Historic Preservation Design Review

HP-12-05, 100 N. Main St. – Rear Entrance & Courtyard (City)

Request: Design review approval to construct a rear entrance courtyard with a water feature, associated fencing and landscaping.

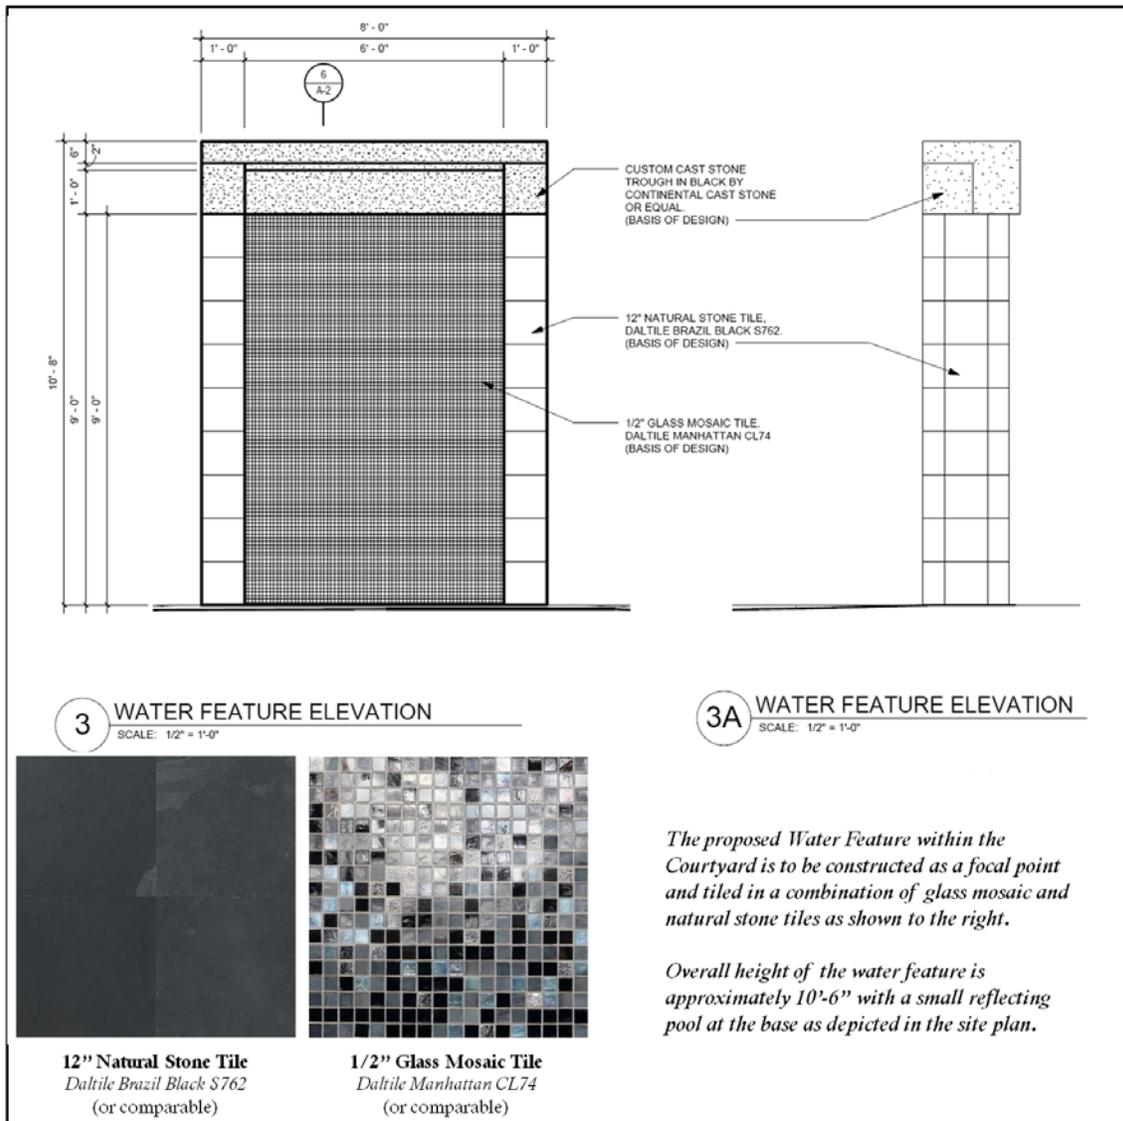
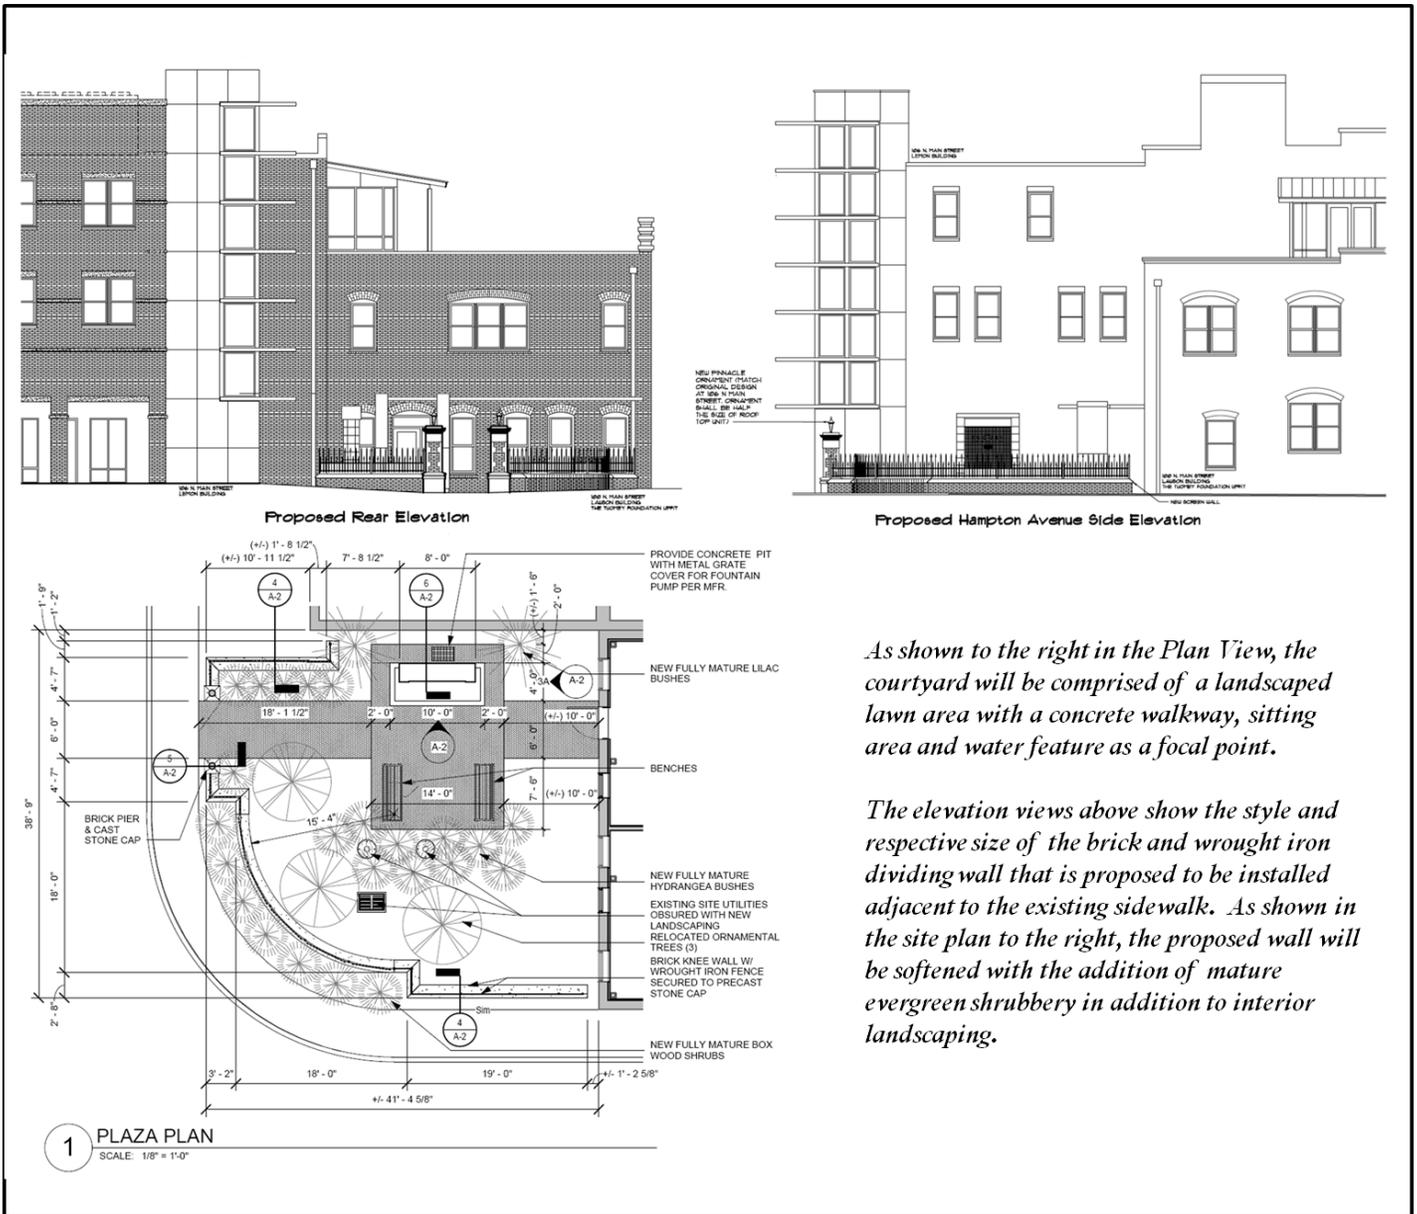
As shown to the right in the Plan View, the courtyard will be comprised of a landscaped lawn area with a concrete walkway, sitting area and water feature as a focal point.

The elevation views above show the style and respective size of the brick and wrought iron dividing wall that is proposed to be installed adjacent to the existing sidewalk. As shown in the site plan to the right, the proposed wall will be softened with the addition of mature evergreen shrubbery in addition to interior landscaping.

The plan excerpts above and on the prior page show the proposed layout for the courtyard space to include landscaping, fencing, and the water feature. Design review is required prior to undertaking the proposed development.

The overall design proposal to include plant selection, planting location, proposed materials and overall street level appearance of the proposed courtyard area are consistent with established Guidelines. This proposal will create a pedestrian scale versatile open space that maintains the established street level rhythm at an appropriate scale.

Staff has reviewed this request in accordance with the design guidelines. Staff recommends approval of this request.
